SMYRNA SCHOOL DISTRICT
Smyrna HS – Athletic Multi-Sport Field Lighting
BID NO. SSD22007-SHS_ATHFL

ADDENDUM NO. 1 07 December 2022
ARCHITECT'S PROJECT NO: 22010

Re: **SMYRNA SCHOOL DISTRICT – MS FIELD LIGHTING**
Smyrna, Delaware
GAI#: 22040 / FCA#:22010

ADDENDUM NO. 1

DRAWING TITLE:
COVER SHEET & SITE KEY PLANS
DWN BY: FCA | CHK BY: KBF | PROJ. NUMBER: 22010
DATE: 11-03-2022 | DRAWING NUMBER:
SCALE: As indicated | **CS10-01**

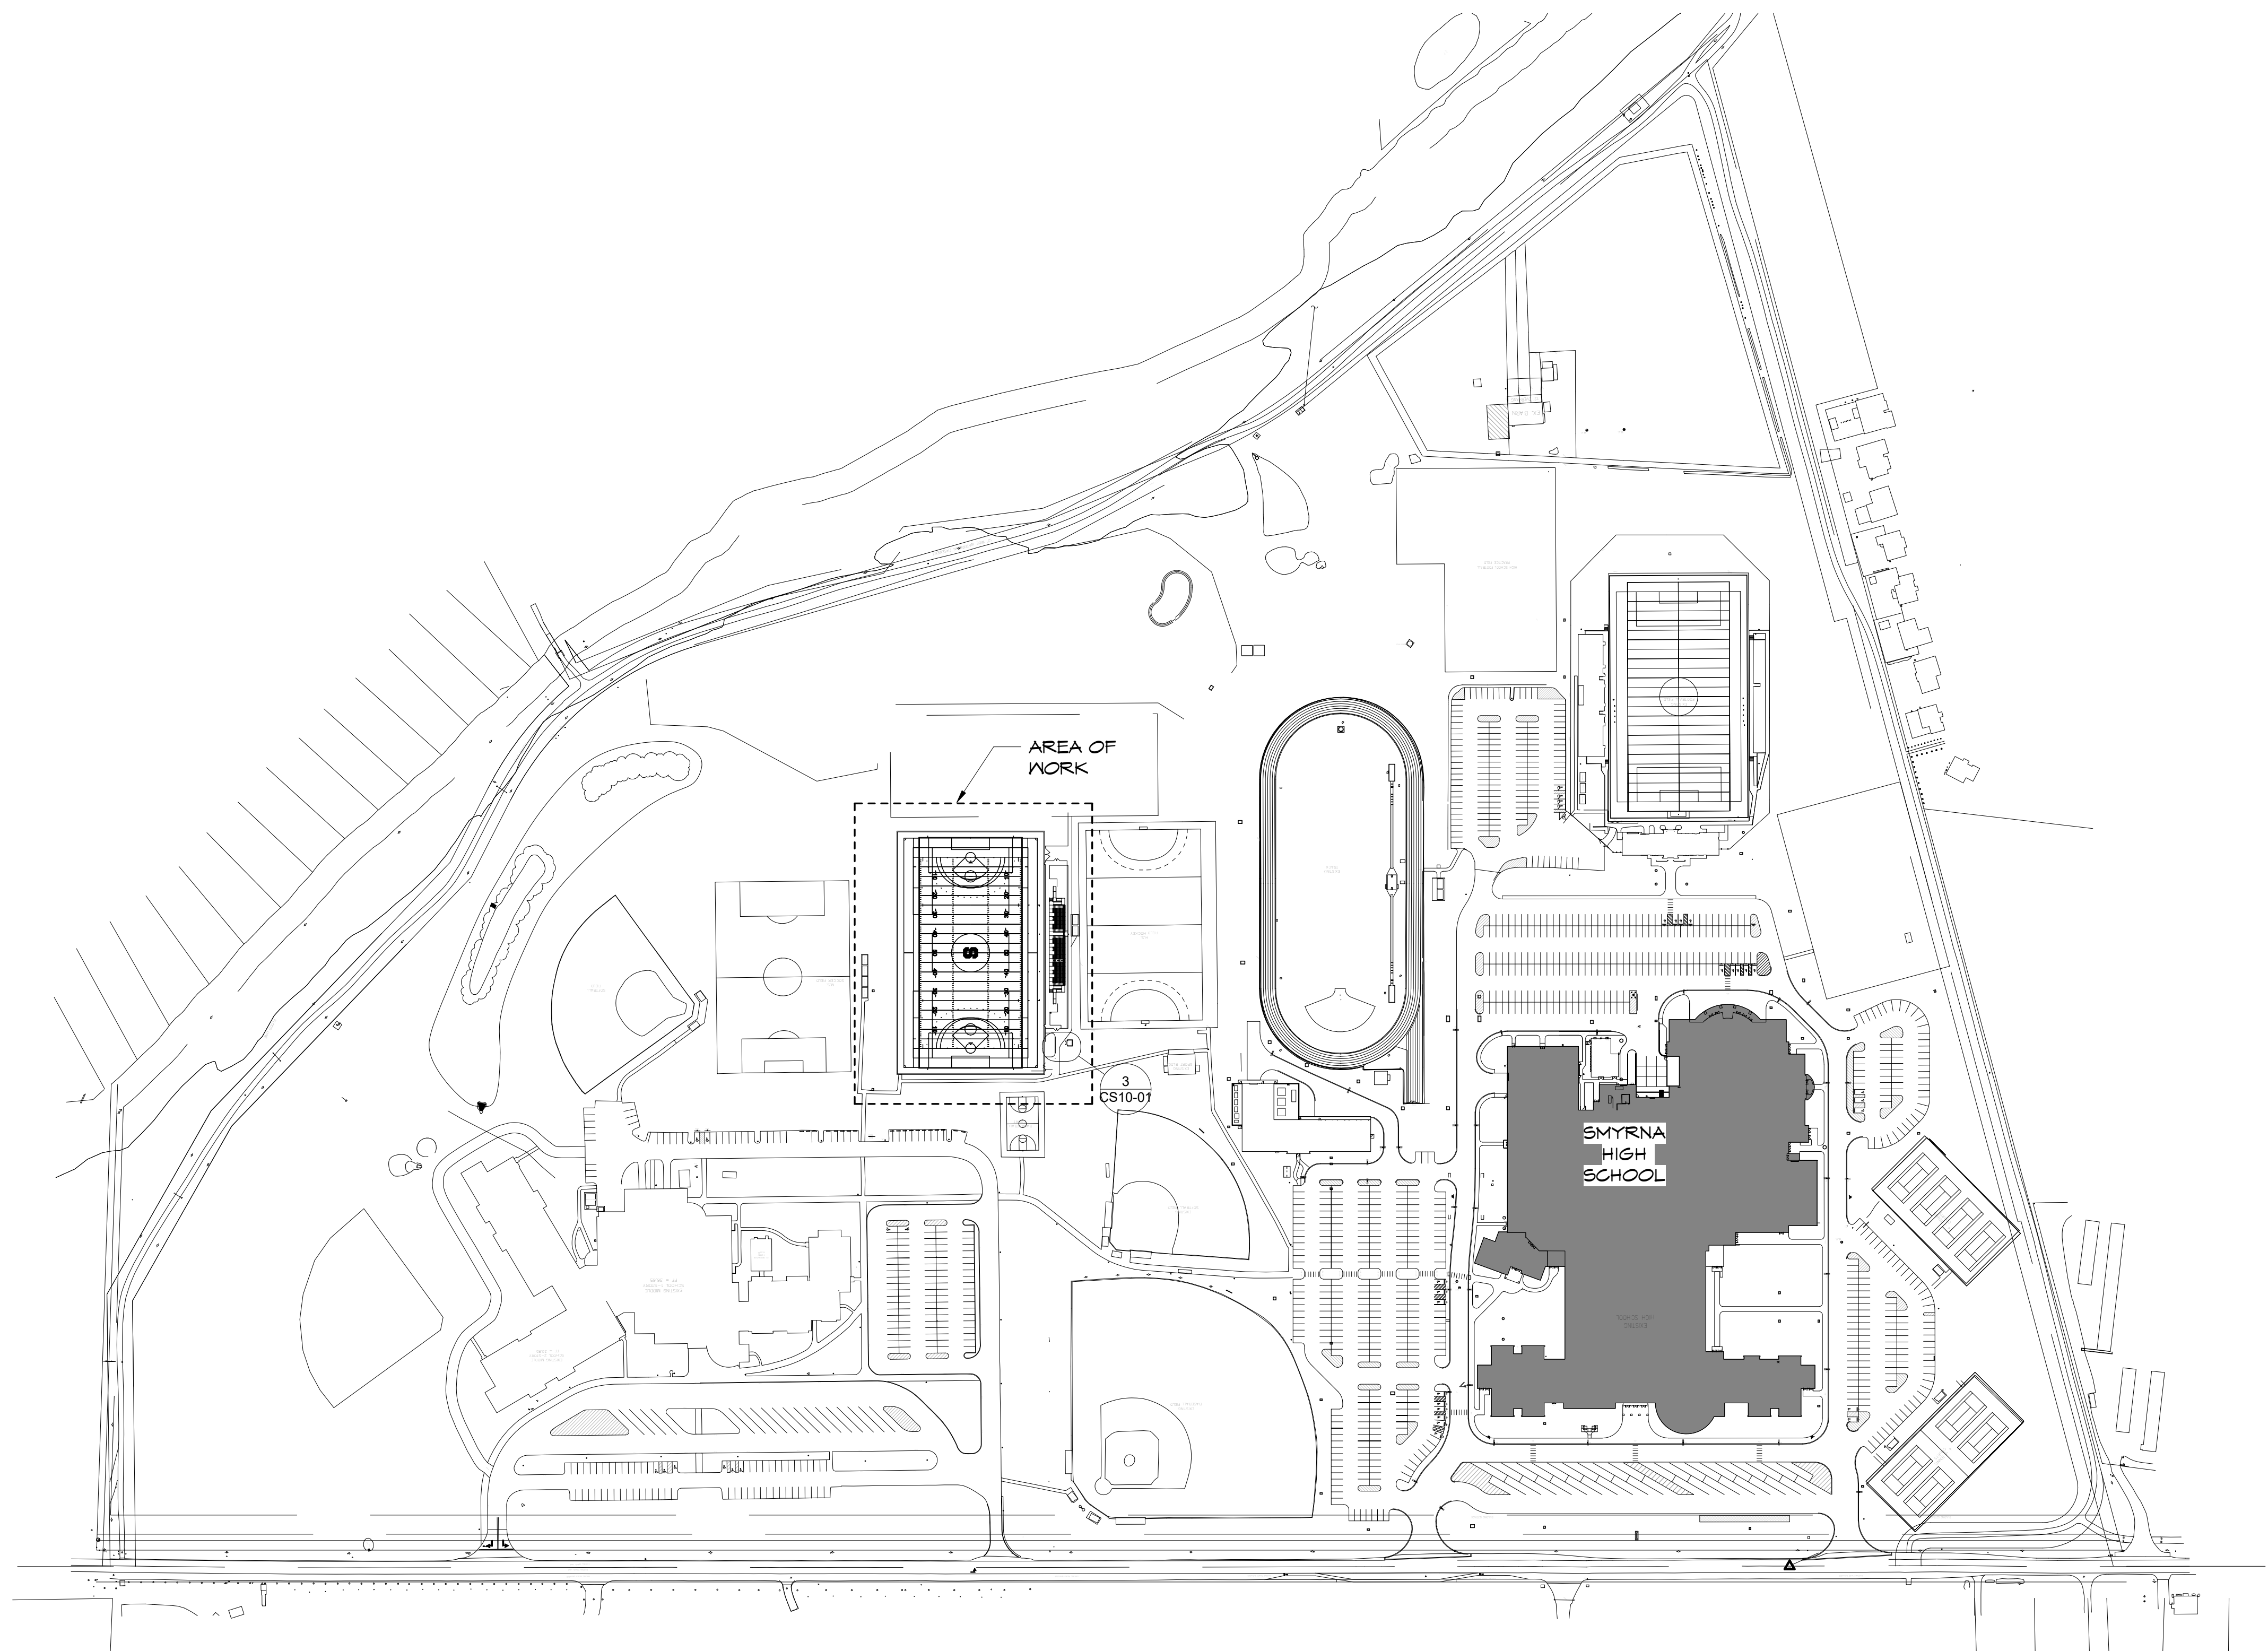
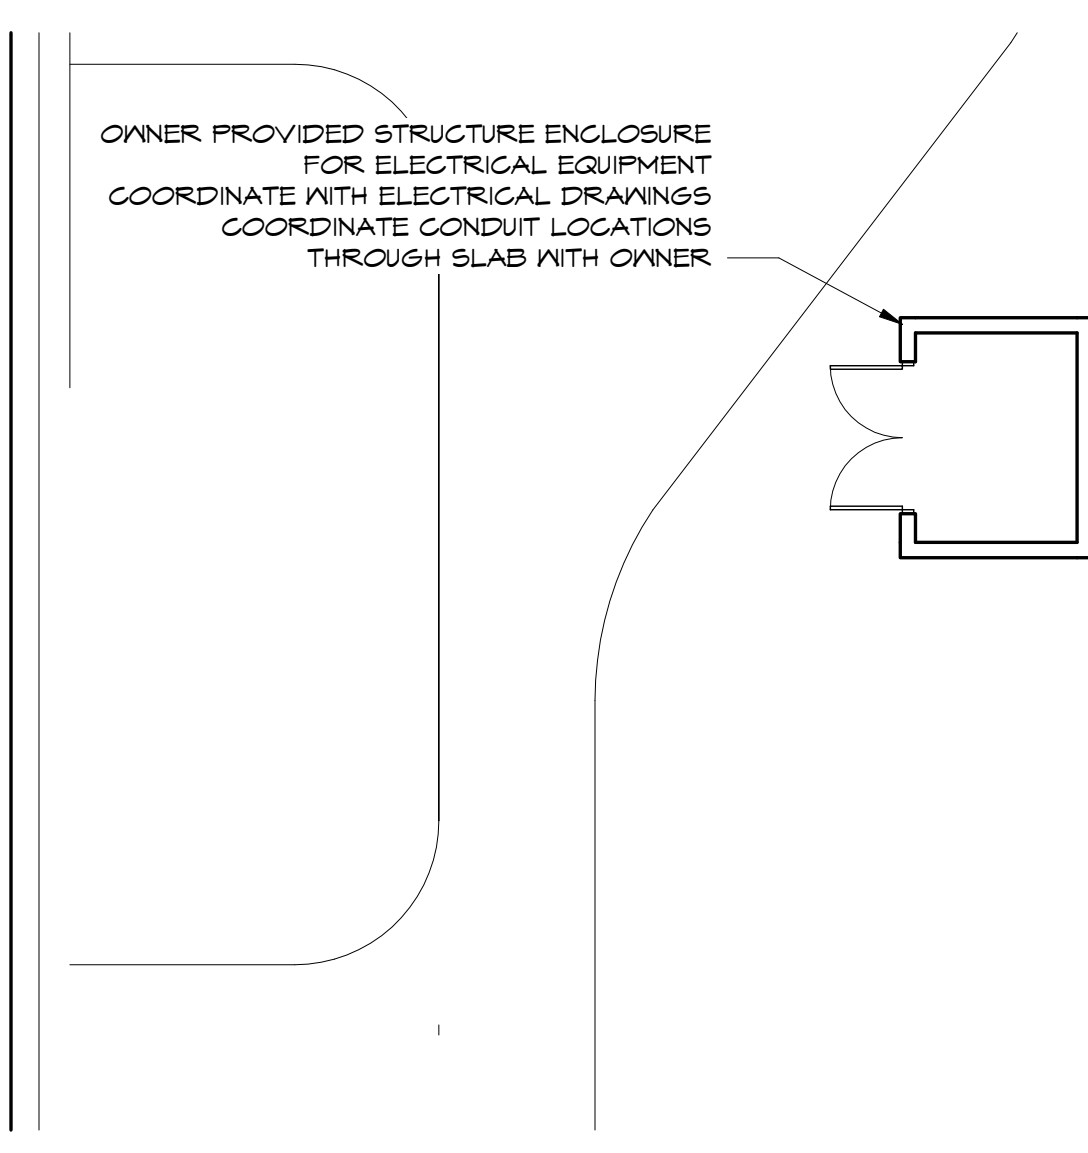
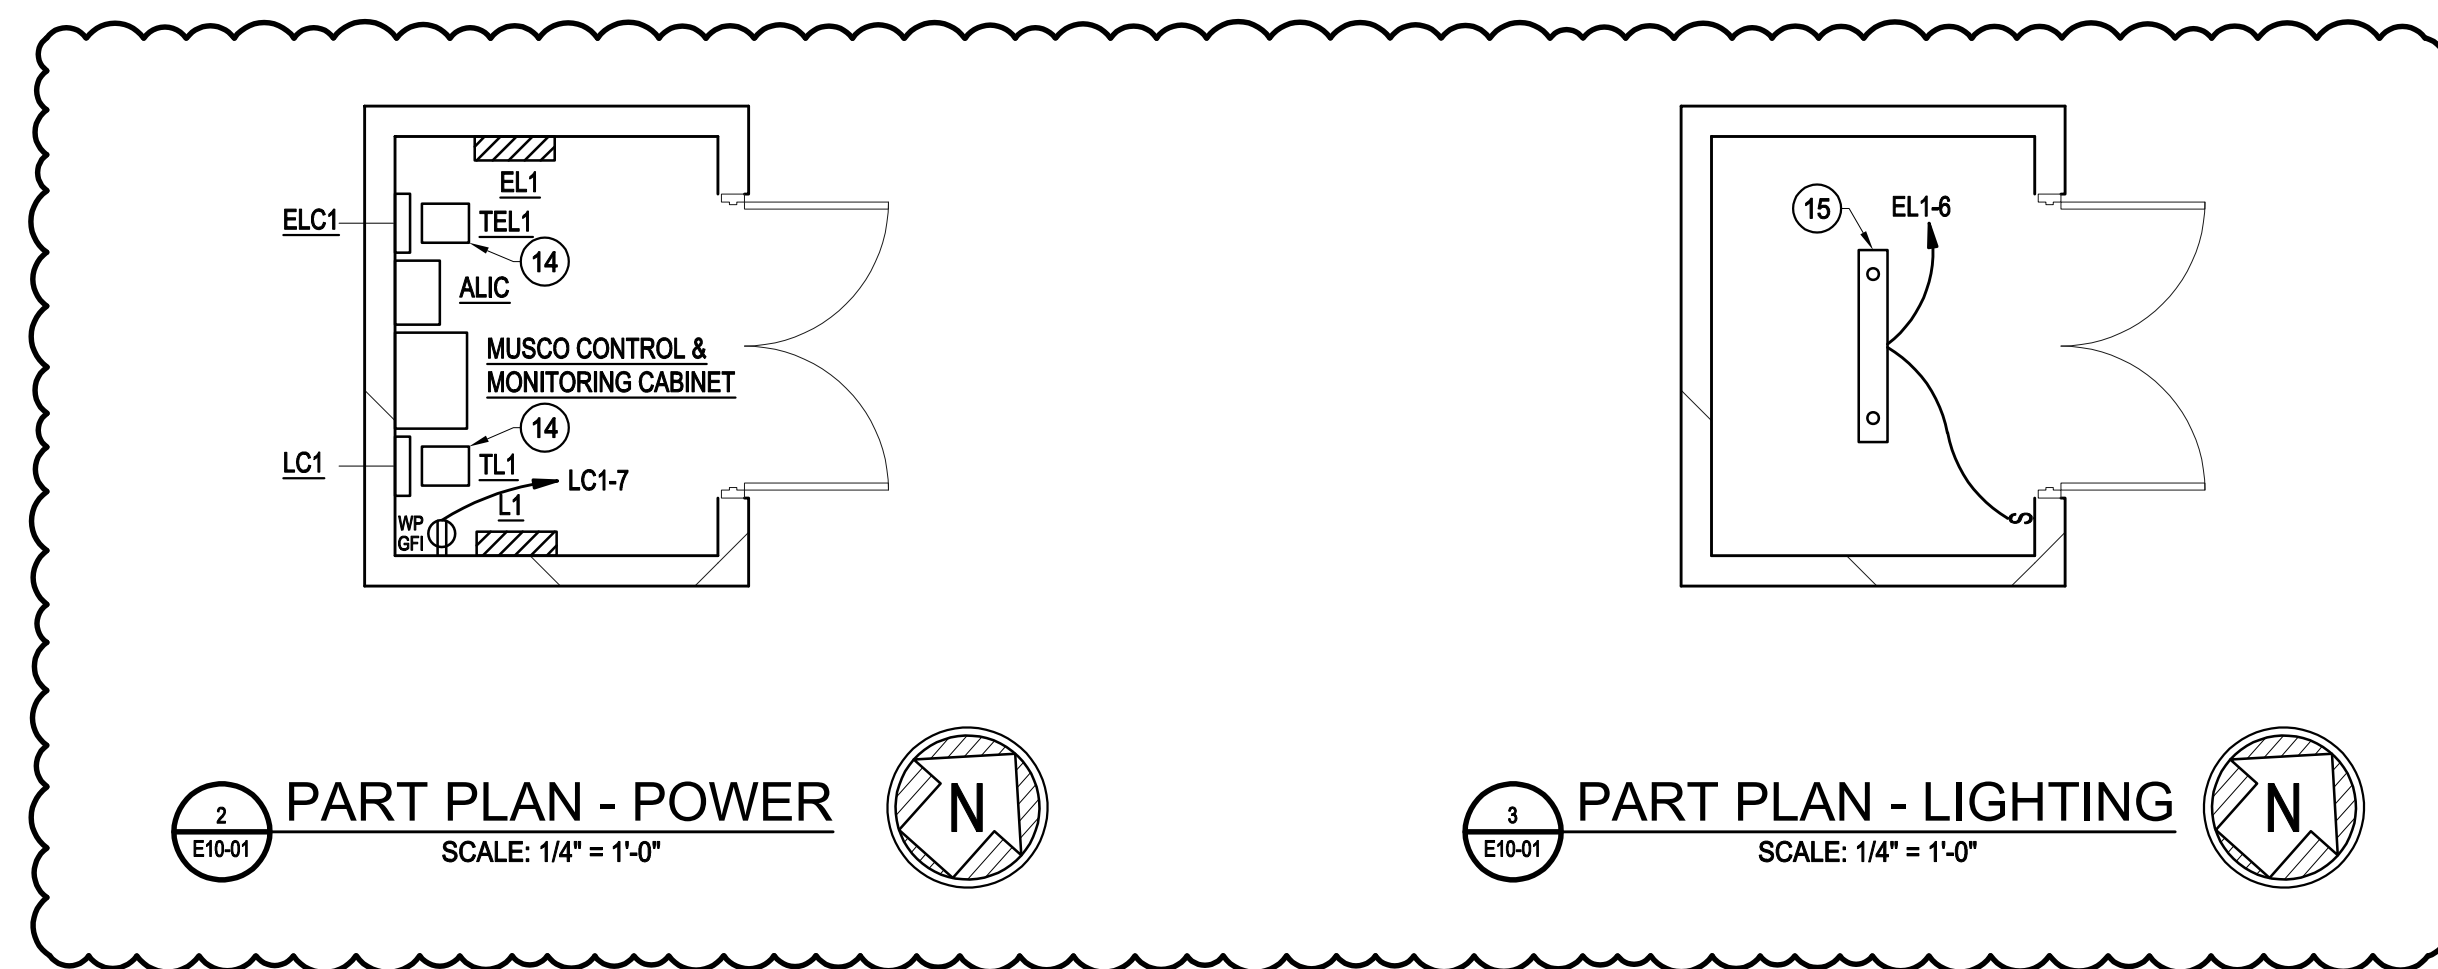
- 5.1 Field Lighting Manufacturer to provide required foundation to meet their system requirements and incorporate the associated geotechnical information. See attached geotechnical report.
- 5.2 See attached Gipe Associates Narrative of Changes.

1. FIELD LIGHTING MANUFACTURER TO PROVIDE THE REQUIRED FOUNDATION DESIGN TO MEET THEIR SYSTEM REQUIREMENTS.
2. GEOTECHNICAL INFORMATION WAS PROVIDED IN ADDENDUM 1, AND SHALL BE INCORPORATED INTO THE DESIGN OF THE FIELD LIGHTING FOUNDATIONS.

DRAWING TITLE: SITE PLAN ELECTRICAL

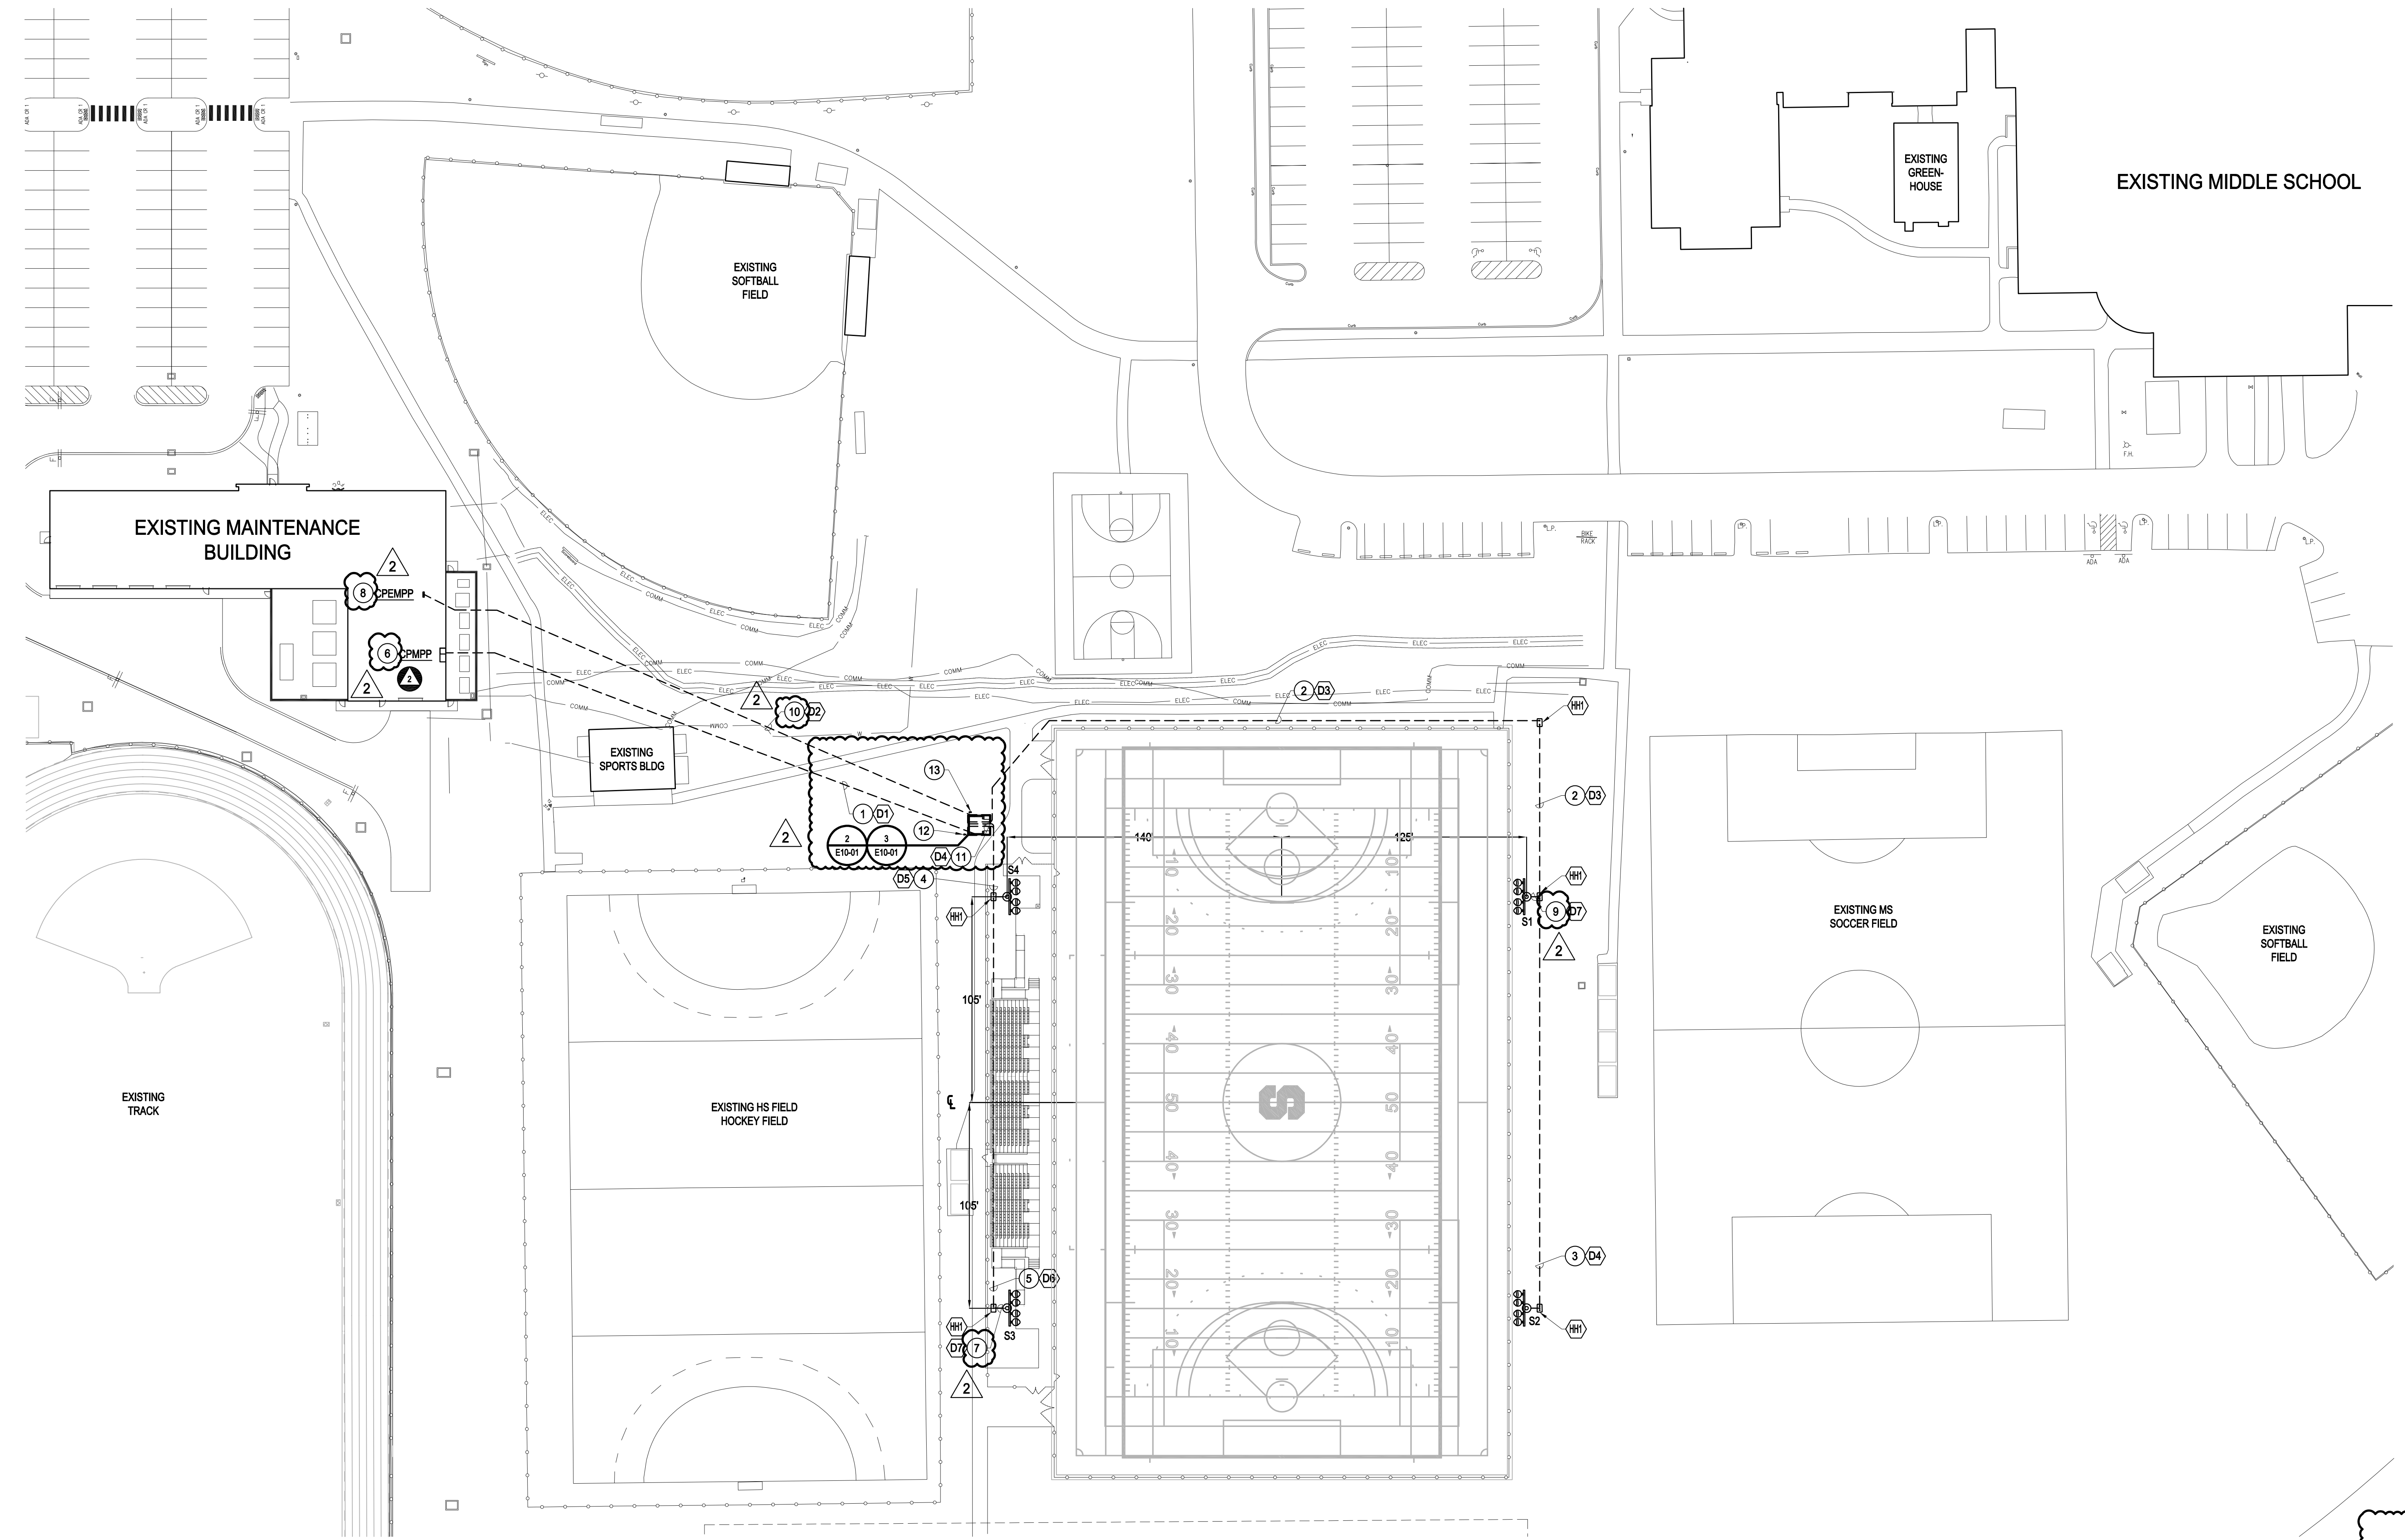
1. Sheet E00-01: Add switch to lighting legend and revise mounting height of receptacle from 18" to 48".
2. Sheet E10-01: Add callouts for building/shed next to athletic field, delete plywood backboard and electrical equipment that was located on the same and revise several drawing notes.
3. Sheet E30-02: Delete details showing plywood backboard, added transformer grounding details and revised lighting control enclosure mounting layout.
4. Sheet E30-03: Delete sheet in its entirety.
5. Sheet E40-01: Revise enclosure ratings and locations of panelboards and load centers. Add circuit #6 to panelboard EL1.
